NEDO-33911-A, Revision 3,  
BWRX-300 Containment Performance

# **BWRX-300 Containment Performance**

SUBJECT: FINAL SAFETY EVALUATION FOR GE-HITACHI LICENSING TOPICAL  
REPORT NEDC-33911P, REVISION 0, SUPPLEMENT 1, "BWRX-300  
CONTAINMENT PERFORMANCE"

**Figure 2-8: FMCRD CIVs Connected to RPV Boundary**

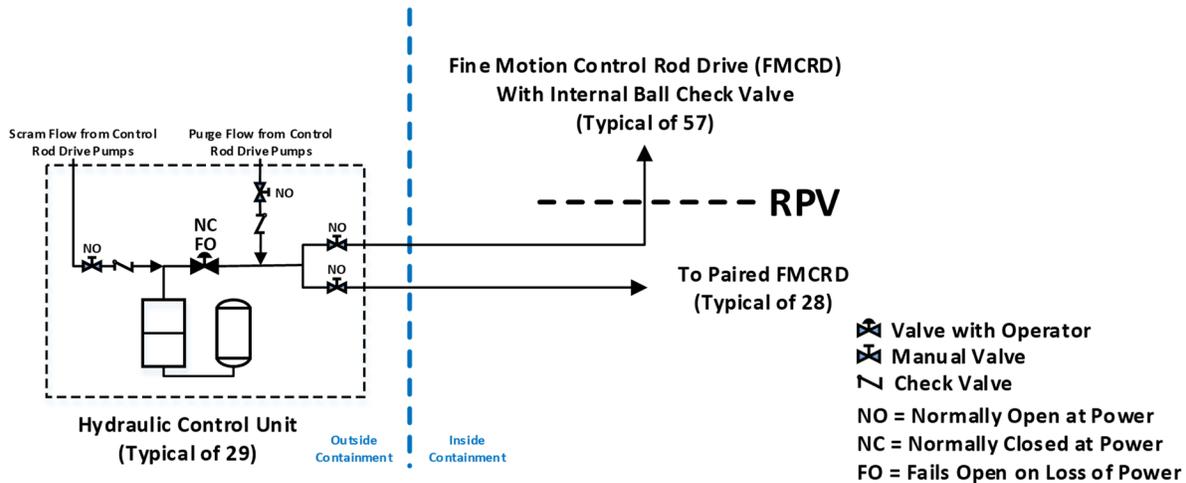
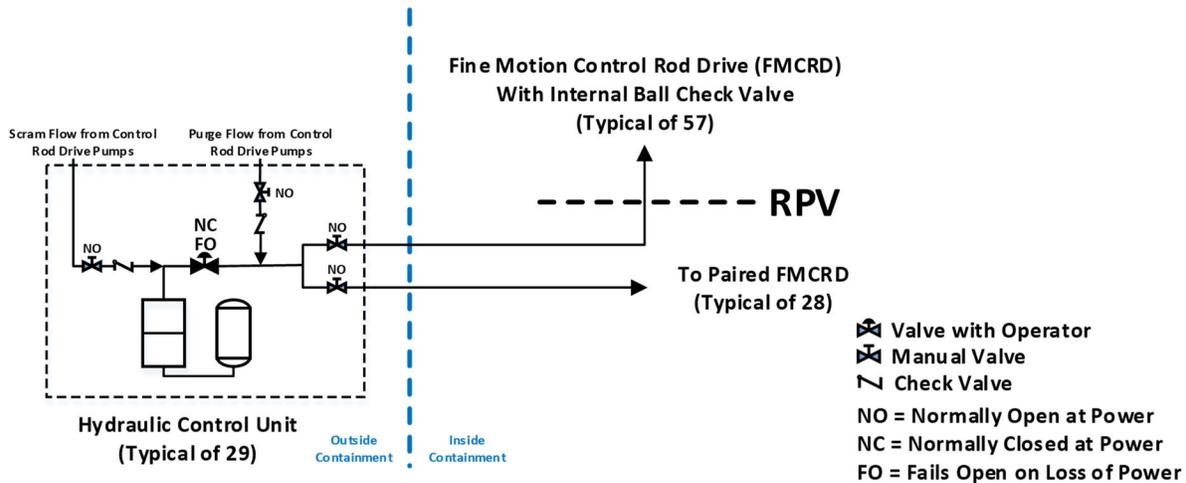
NEDC-33911, Section 2.2.7.1 states that the containment penetrations for fine motion control rod drive (FMCRD) hydraulic lines (shown on Figure 2-8 of NEDC-33911) do not have isolation valves based on closed-system piping outside the primary containment vessel (PCV) and reactor coolant pressure vessel (RCPB) isolation valves (internal ball check valves) in the design of the drives.

Figure 2-9: CIVs Connected to Containment Atmosphere

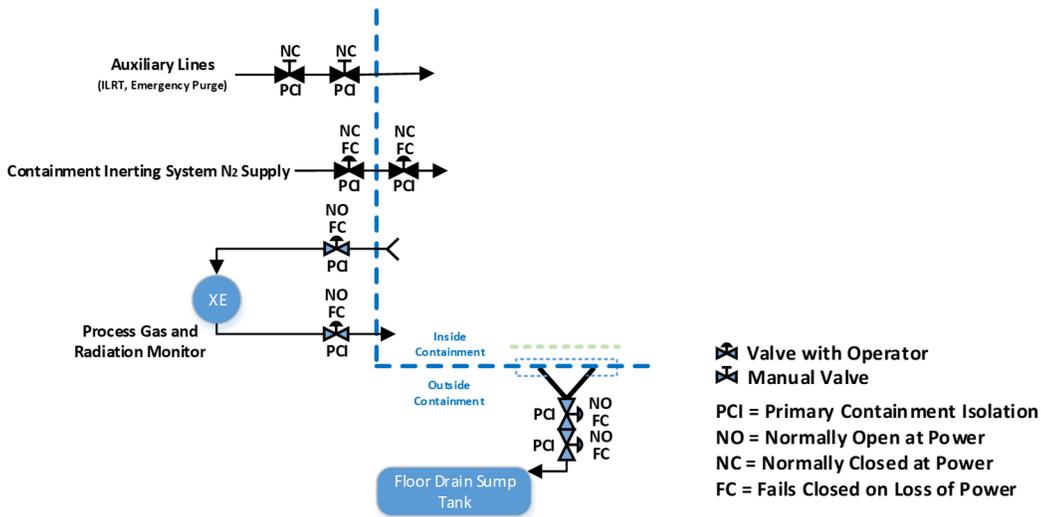
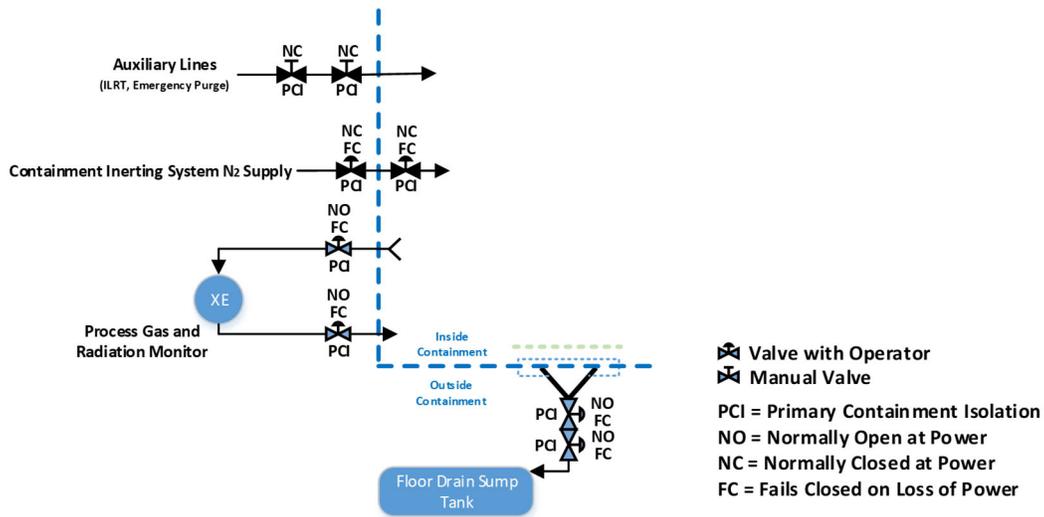
The NRC staff finds that the approach described in NEDC-33911P, Section 5.1.23, Section 2.2.7.2, and Figure 2-9 to be consistent with GDC 56 and, therefore, is acceptable. The NRC staff will conduct a detailed evaluation to confirm that GDC 56 is satisfied when it receives an application for a BWRX-300.
